MISSISSIPPI POWER & LIGHT COMPANY

September 23, 1981

SUBJECT: Grand Gulf Nuclear Station  
Units 1 and 2  
Docket Nos. 50-416 and 50-417  
File 0260/L-334.0/L-350.0  
Response to Structural  
Engineering Branch Request  
for Additional Information;  
Damping Value for Cable Tray  
Design, SER 1.9(1)  
AECM-81/357

**FIGURE 39-1 DAMPING VS. INPUT LEVEL FOR BRACED HANGER SYSTEMS**

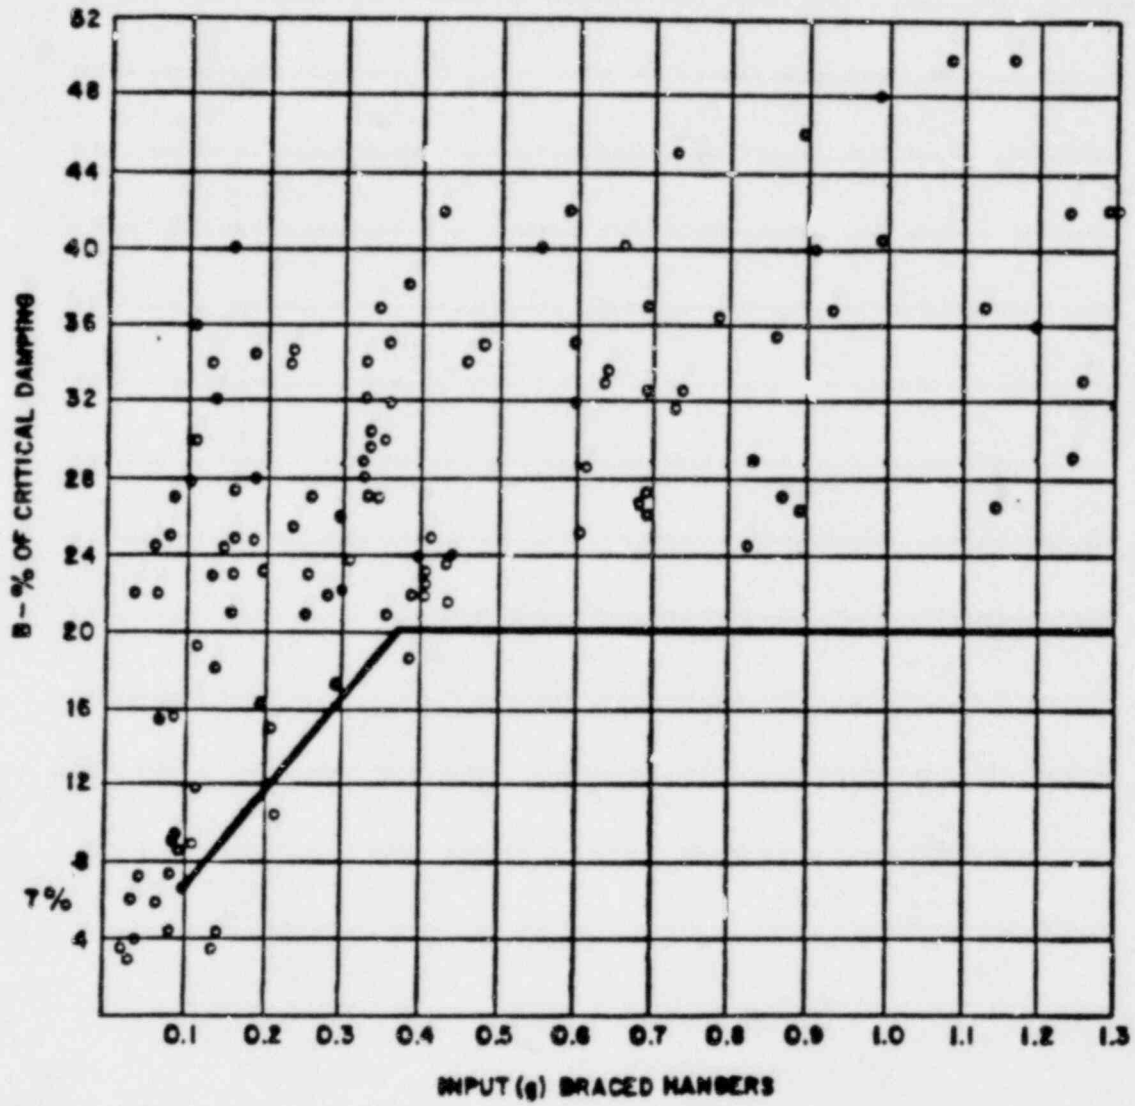
1. Provide a discussion on how major cable tray test results were used in arriving at the 20% modal damping. The discussion should assure consistency of observed data and calculations used.

The computed damping values from the various tests are tabulated in Appendix K of the test report. Data was taken from these tables and plotted as shown in Figure 39-1 (Attached). On this figure, the data points of computed equivalent viscous damping are plotted as function of input acceleration (floor spectrum ZPA) for over 100 tests of various braced strut hanger tray systems. These results represent all the data from simulated earthquake inputs. Low level sinusoidal and snap back test data are not included since they are not directly applicable. Since these tests represented a wide variety of tray type, connection details, struts, and cable configuration, there is a broad scatter in the data. These data, however, do clearly show that the recorded responses of the tested tray systems is best described by a dynamic system with an equivalent viscous damping. It should be noted that the data realistically can be utilized with accepted curve fitting techniques to obtain a "best-fit" curve which reflects the statistical average of the test data. Such an approach would result in a maximum damping value far in excess of the conservative 20% value. However, in the interest of conservatism, a bilinear curve, which effectively bounds

the lower end of nearly all the points, was utilized. This curve, given in Figure 39-1, represents the recommended design values of equivalent viscous damping.

FIGURE 43-1 LOWER BOUND DAMPING AS A FUNCTION OF INPUT ZPA

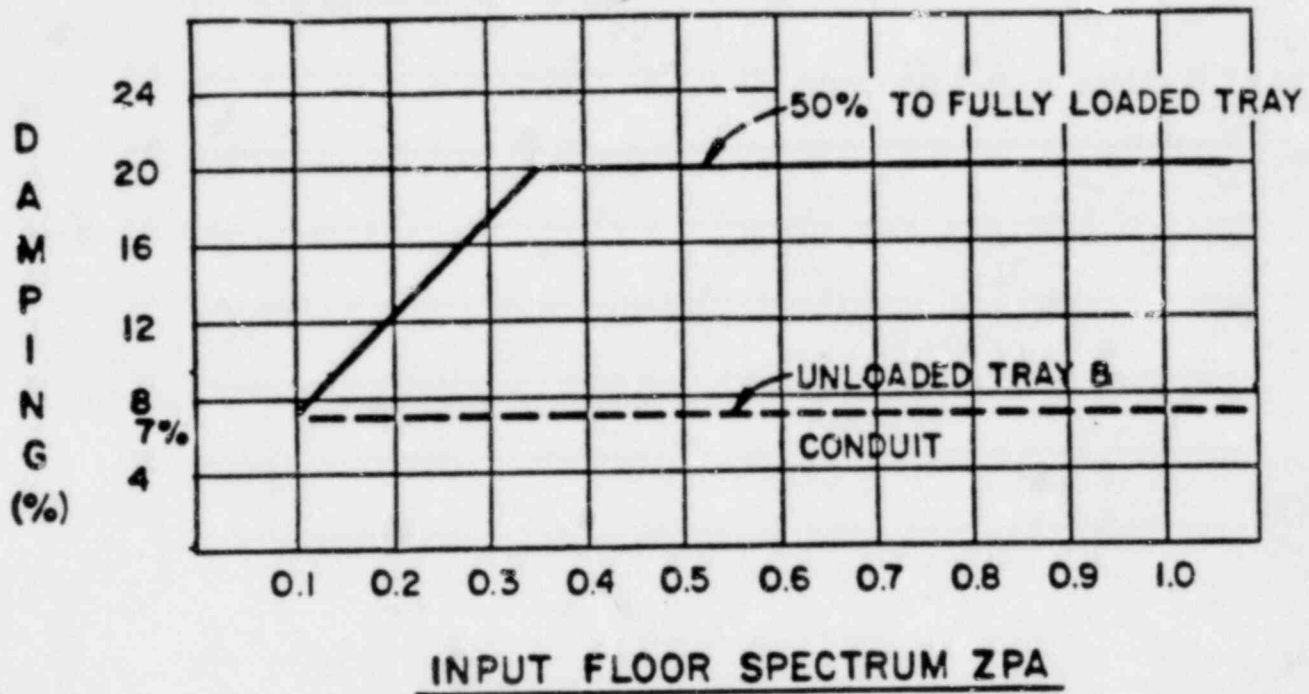
5. Specify different conditions under which different modal damping ratios ranging from 7-20% are used. (cable tray)

Damping of the cable tray system is dependent on the amount of cable in the trays and the input amplitude of vibration. Figure 43-1 presents the lower bound values of equivalent viscous damping as a function of input floor response spectrum ZPA and the amount of cable in the tray. To be able to use the maximum value of damping, 20%, the instructure response spectra must have a ZPA value of at least 0.35g and the tray must be at least 50% full, by weight, of cable.
